3. 1700 Westbrook Street (Stroudwater Preserve) - Workshop, Wednesday, 10/4/17, 4:30 P.m.

**LEGAL ADVERTISEMENT
PORTLAND PLANNING BOARD
MEETING AGENDA**

To: Elizabeth Boepple, Chair and Members of the Portland Planning Board
From: Shukria Wiar, Planner
Date: September 29, 2017
Re: Stroudwater Preserve, 1700 Westbrook Street, Stroudwater Development Partners LLC
Project #: 2017-193 CBL: 229 A002
Meeting Date: October 4, 2017

C-50

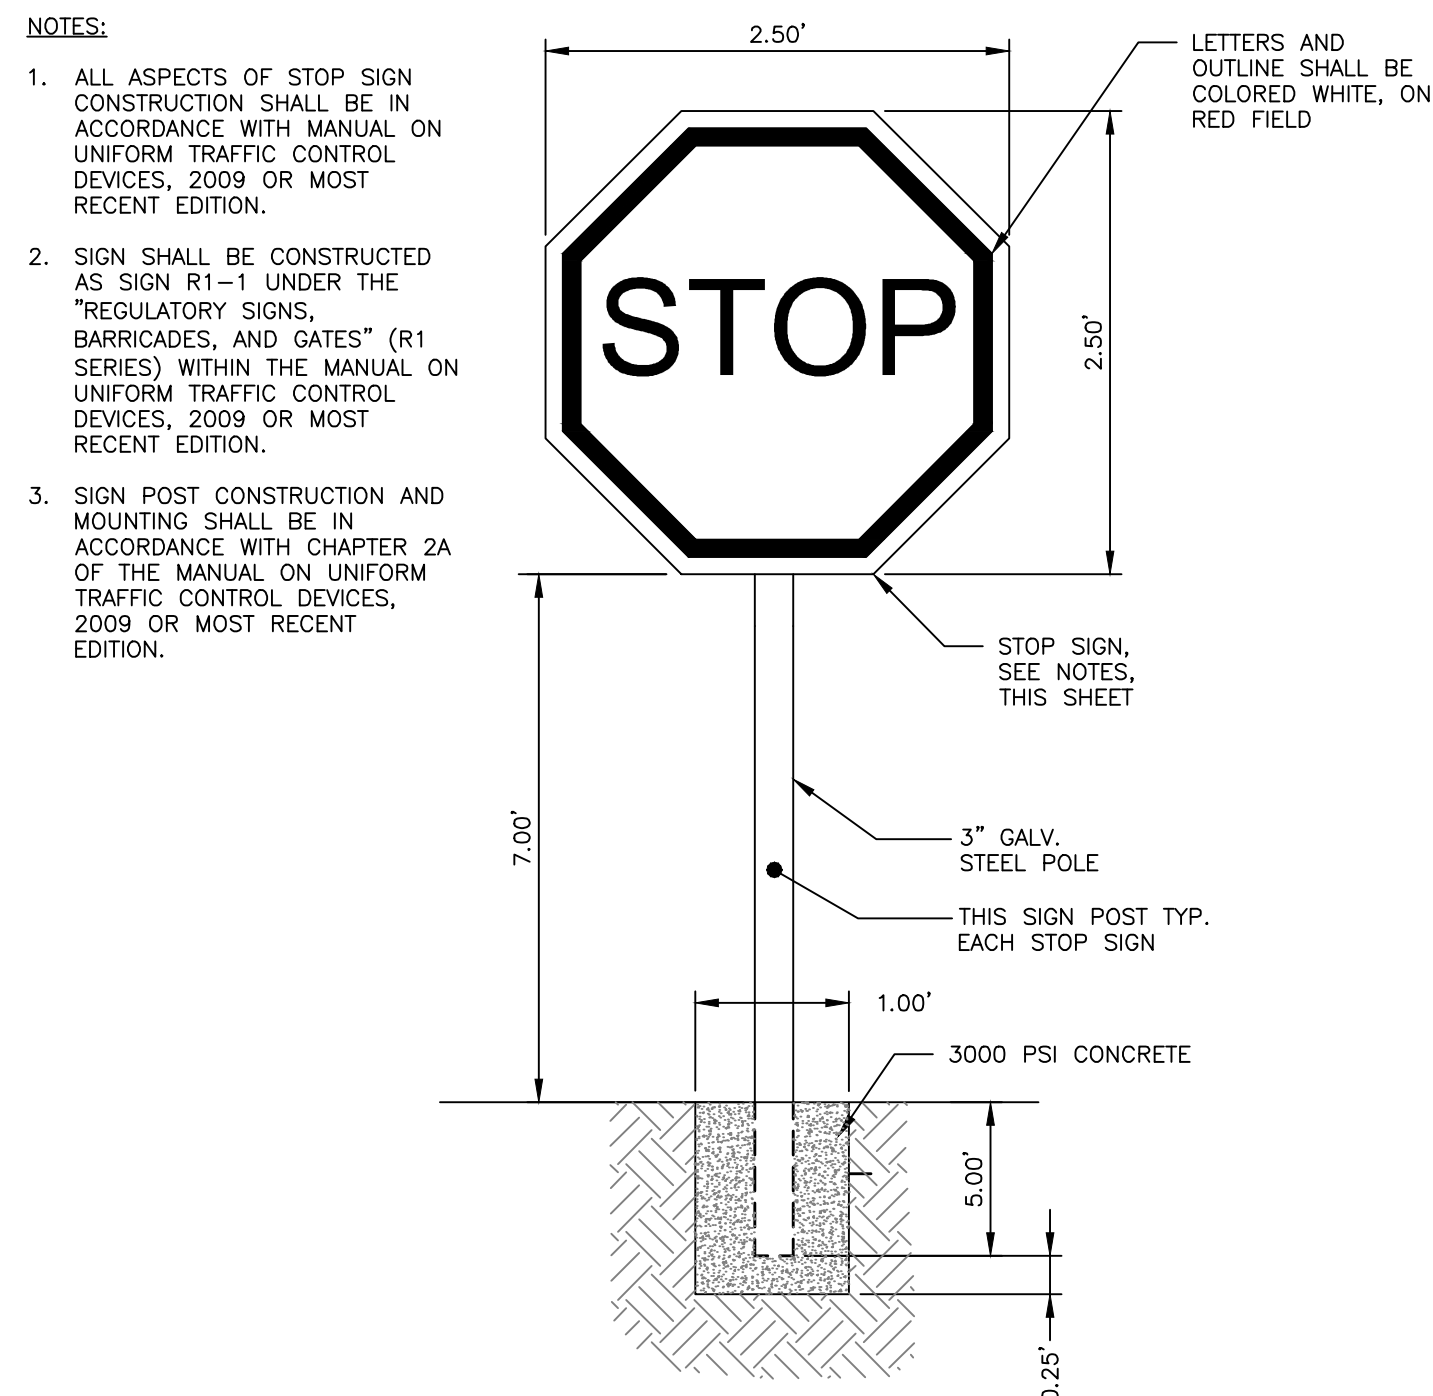
- 3) Please check detail reference for the earthen berm depicted on Sheet C-10 of the plan set. The detail seems to be located on Sheet C-50.
- 4) Index contours (30', 40', 50') for proposed grading are missing in the plan view details on Sheet C-57.
